ADDENDUM NO. 2

Issue Date: April 29, 2021

Project Name: South Oslo Road WTP Improvements

Bid Number: 2021026

BULK CAUSTIC STORAGE TANK AND CONTAINMENT

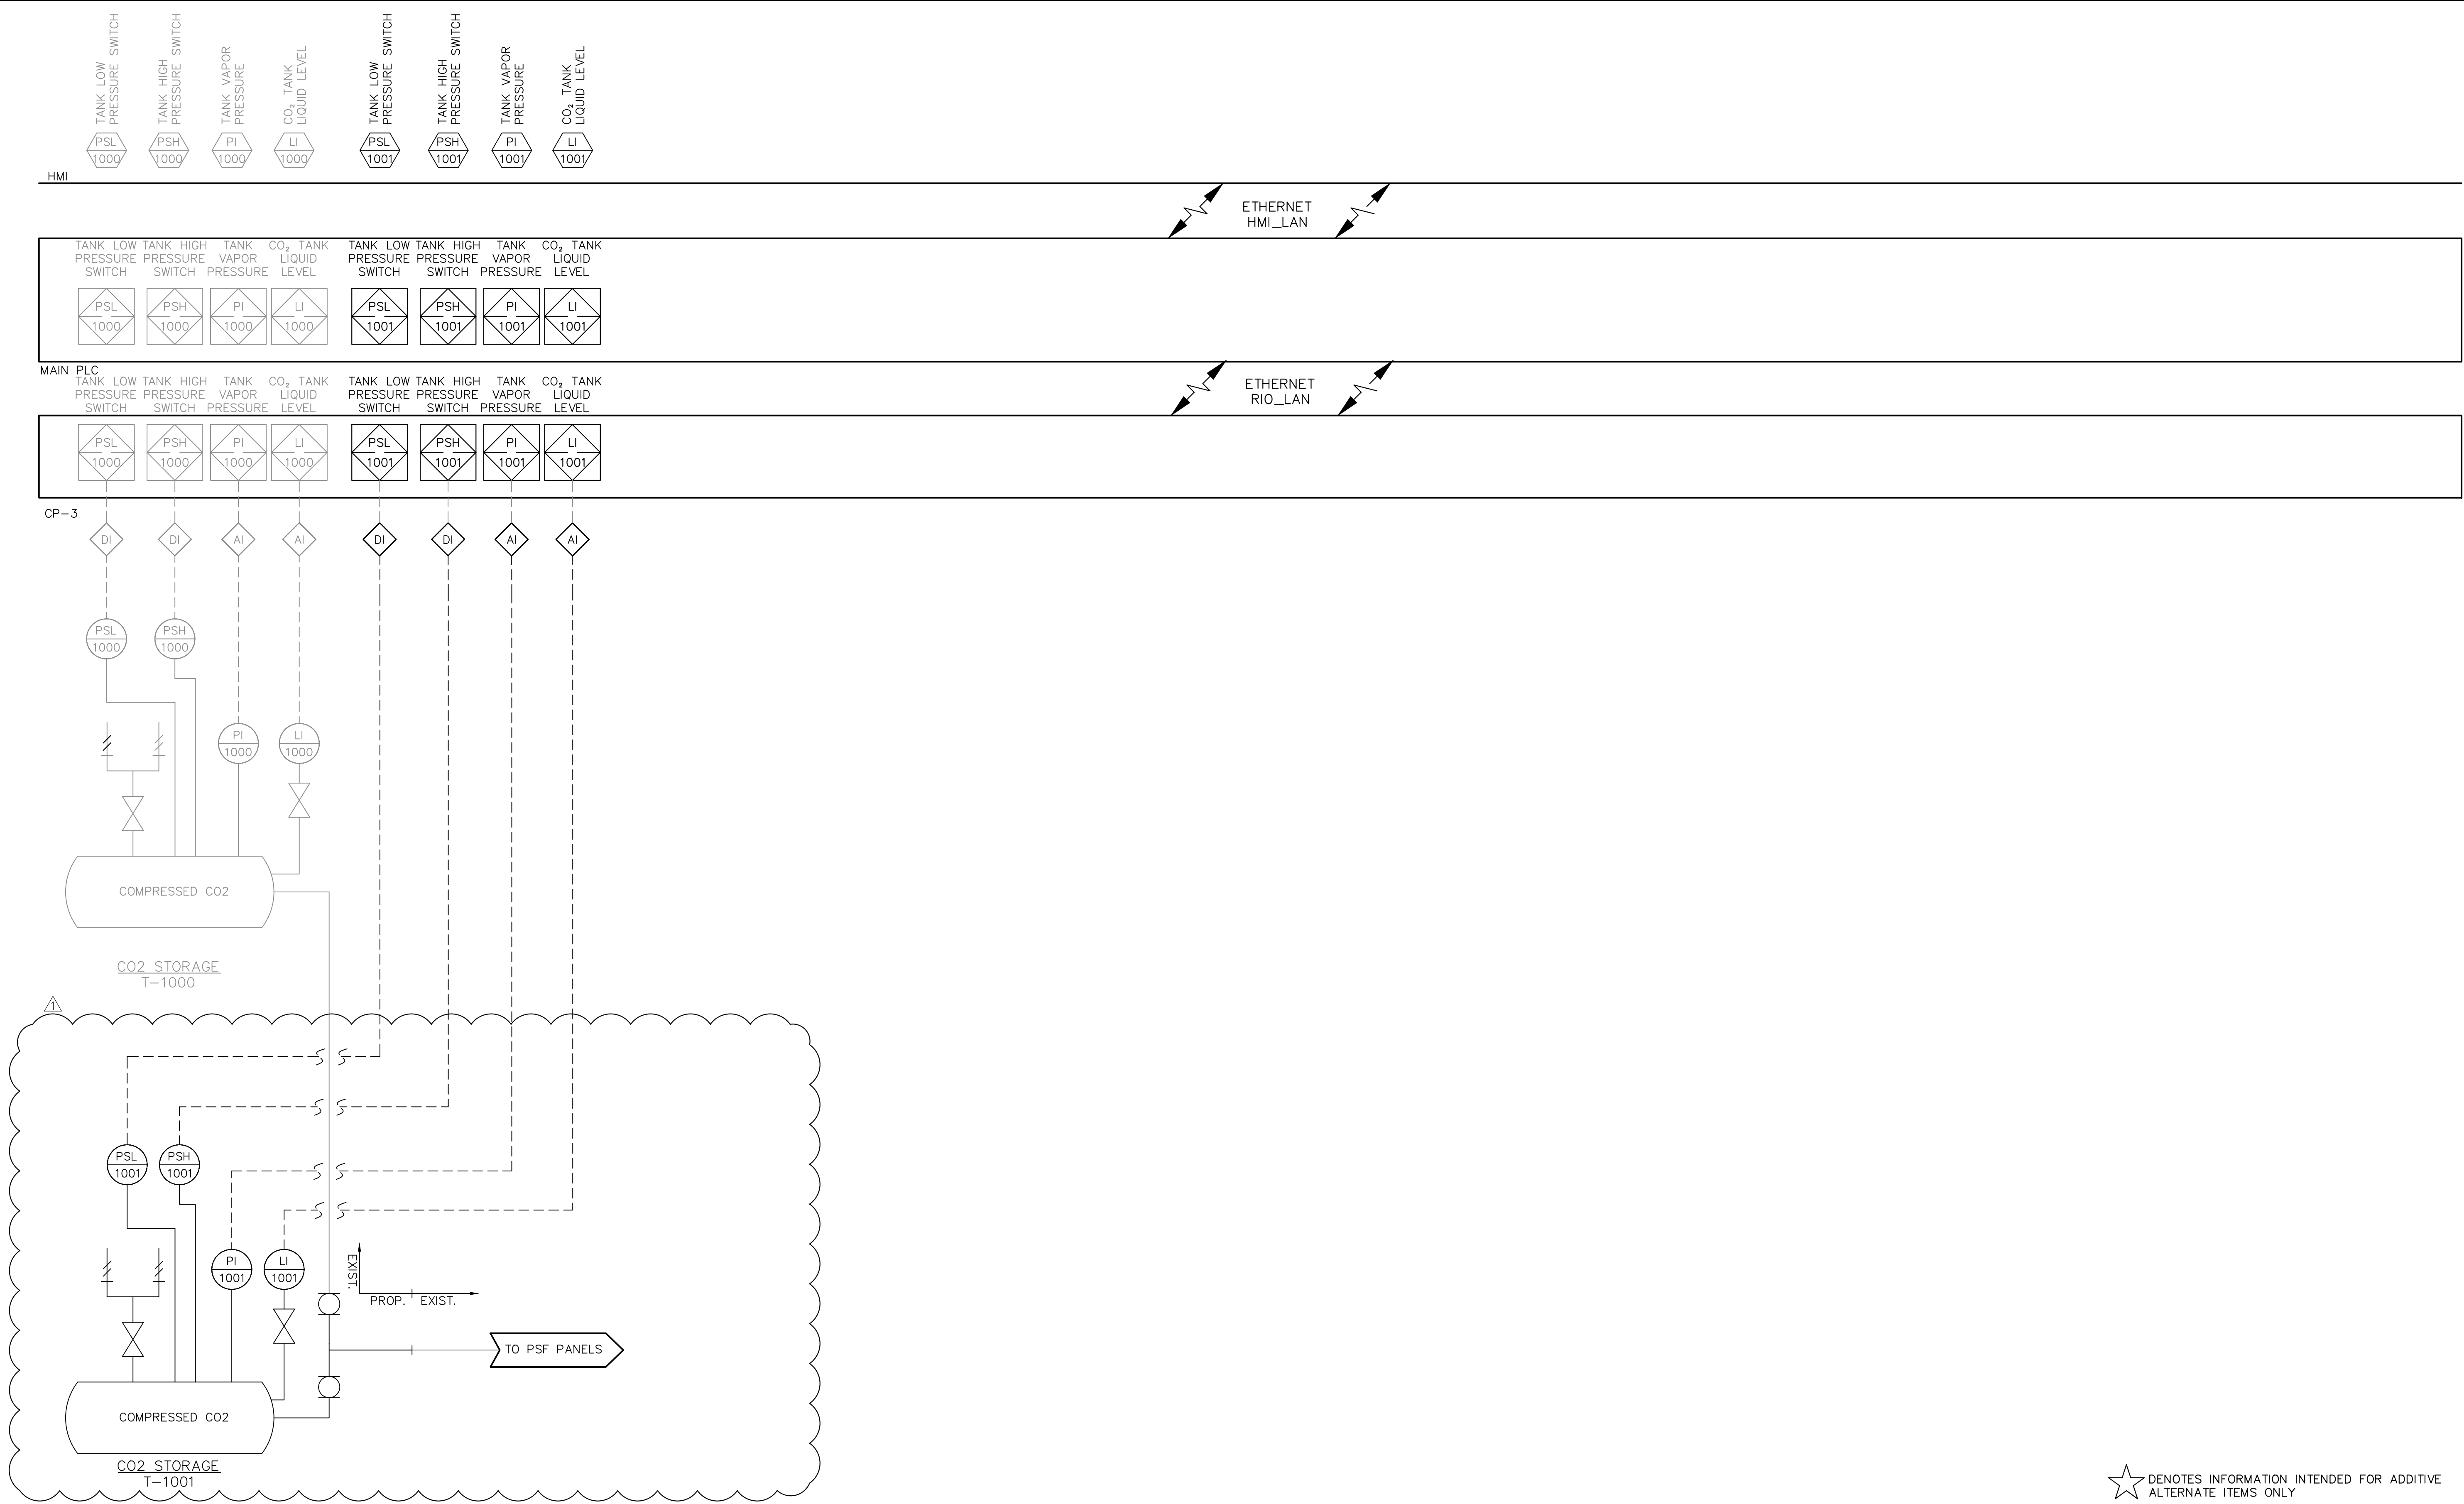
Question #4: Bulk Caustic containment area drawings states that floor, walls and supports have to be coated with a secondary containment system but there is no system included in the Specifications for this application. Please determine which (CRC-1, CRC-2 or CRC-3) and desired thickness.

Response: **Sheet C-16** has been revised to call for coating of the new tank pedestal supports, only. The floor topping and coating system for floors and walls has been removed from the scope of work. Utilize coating system described under 09900-2.5 B.3 for tank pedestal supports.

BULK CAUSTIC STORAGE TANK ELECTRICAL PLAN

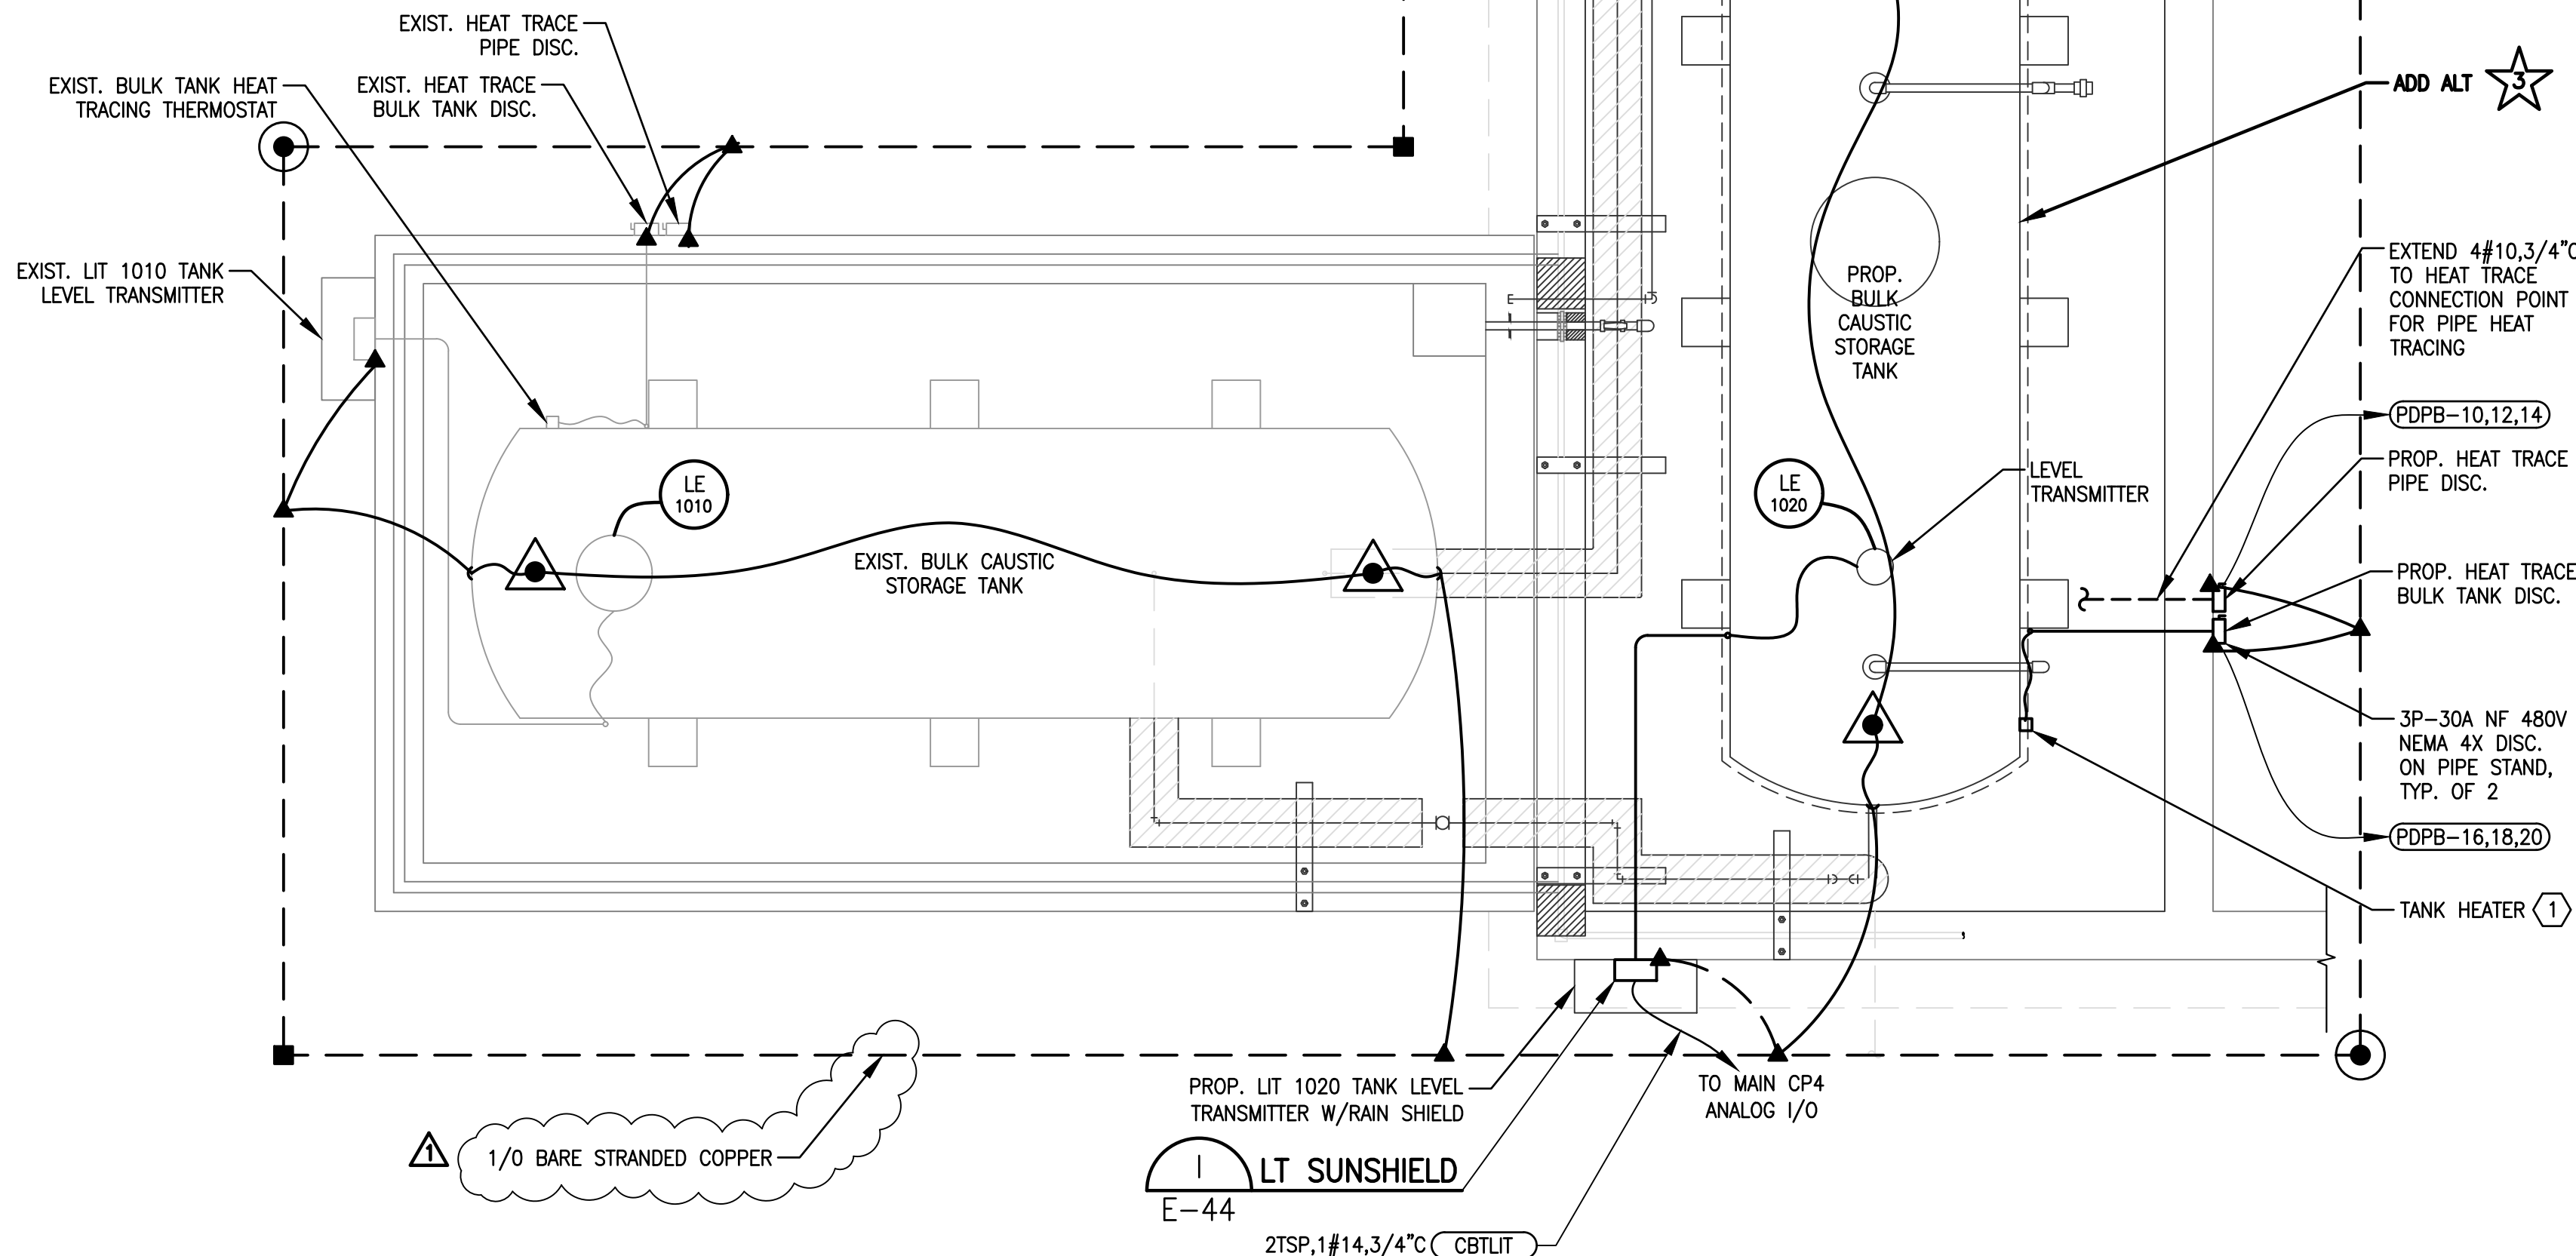
Question #7: Sheet E-10 Bulk Caustic Tank: I do not see the size of the bare grounding conductor

Response: The size of the bare stranded conductor is 1/0 copper. Refer to updated **sheet E-10** included in this addendum response.
